# HISTORIC AND DESIGN REVIEW COMMISSION

**HDRC CASE NO:** 2021-310  
**ADDRESS:** 311 MUNCEY  
**LEGAL DESCRIPTION:** NCB 1657 BLK E LOT N 51 FT OF 15&16  
**ZONING:** R-5, H  
**CITY COUNCIL DIST.:** 2  
**DISTRICT:** Dignowity Hill Historic District  
**APPLICANT:** AEONIUM INVESTMENTS LLC  
**OWNER:** AEONIUM INVESTMENTS LLC  
**TYPE OF WORK:** Installation of porch railing  
**APPLICATION RECEIVED:** June 14, 2021  
**60-DAY REVIEW:** Not applicable due to City Council Emergency Orders  
**CASE MANAGER:** Edward Hall

## REQUEST:

RECOMMENDED DETAIL

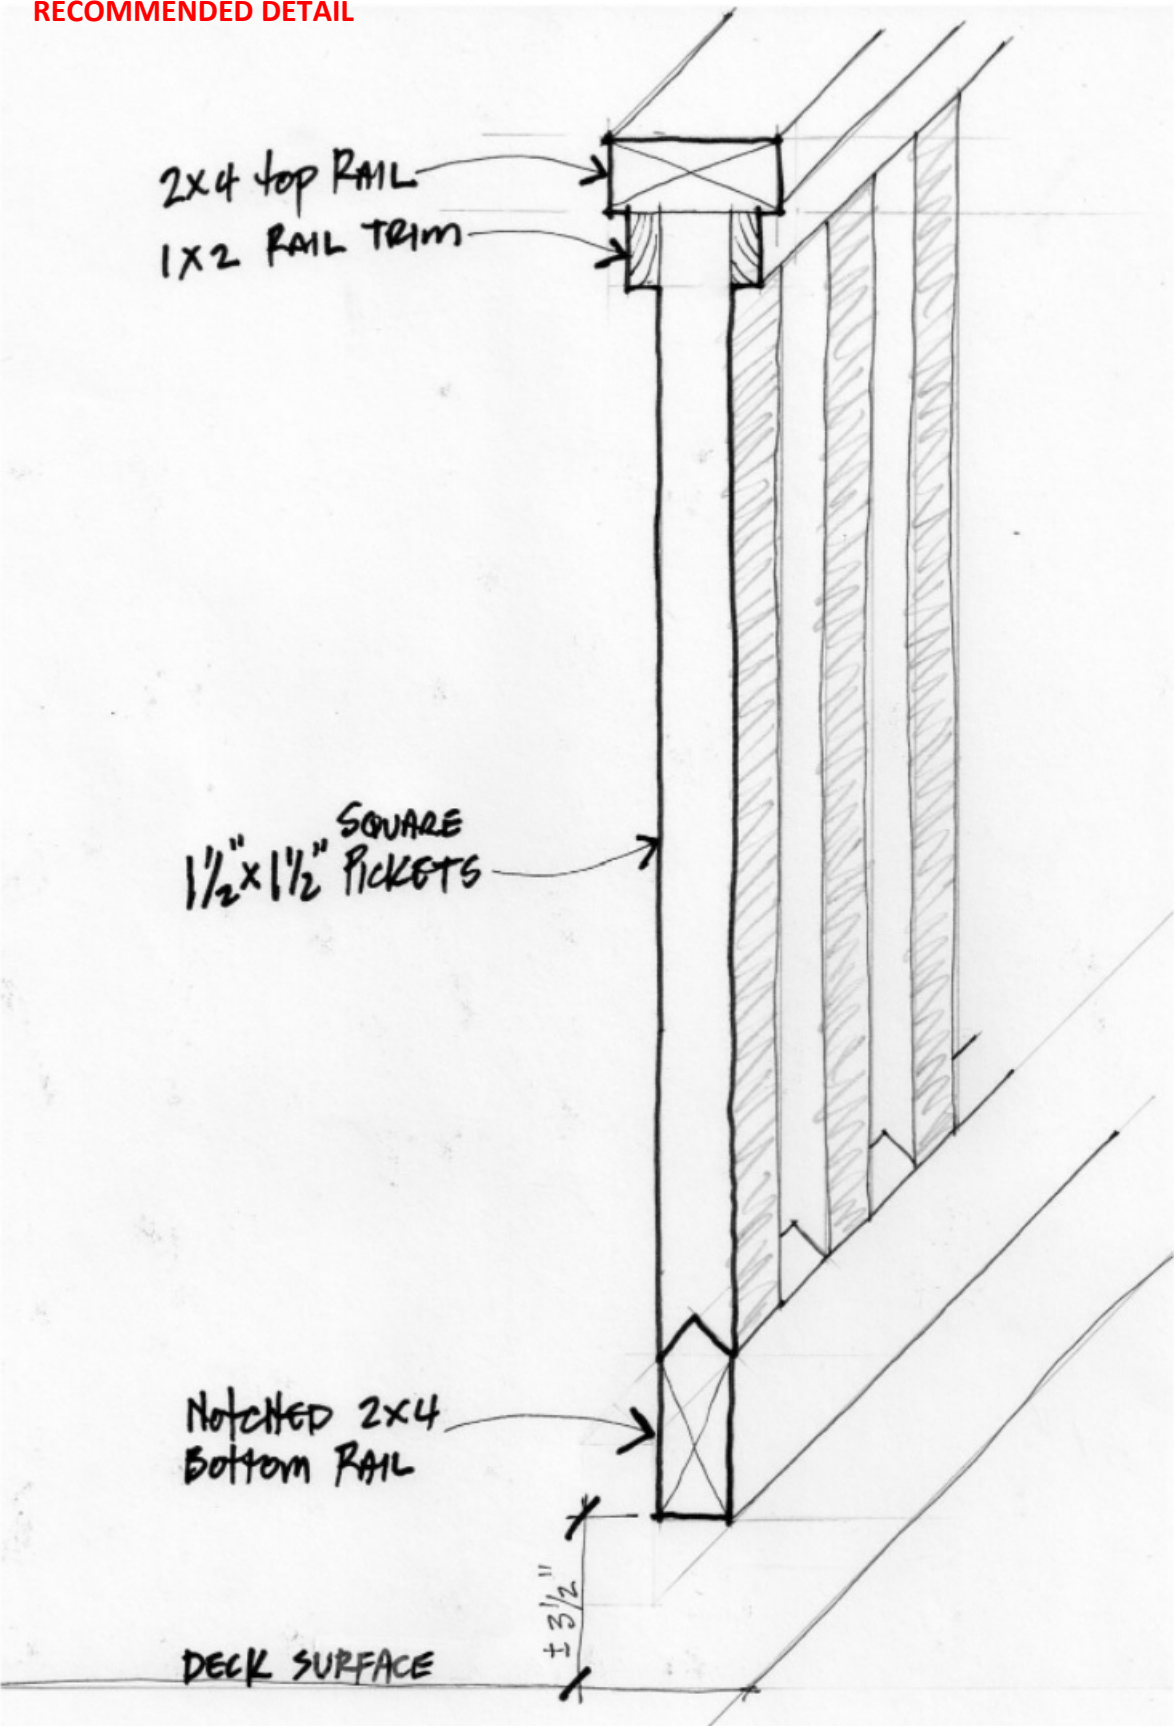
- d. PORCH RAILING – The applicant has proposed to install porch and porch step railing. Generally, staff finds the installation of porch railing to be appropriate; however, it should be designed in a manner that is architecturally appropriate with both the design of the historic Craftsman house and the Historic District. Staff has included an example of architecturally appropriate porch railing in the exhibits.

Staff does recommends approval based on findings a through d with the stipulation that porch railings with an appropriate profile be installed, as noted in finding d. A detailed drawing has been included in the exhibits for reference.

2x4 top RAIL

1x2 RAIL TRIM

SQUARE  
 $1\frac{1}{2}" \times 1\frac{1}{2}"$  PICKETS

NOTCHED 2x4  
Bottom RAIL
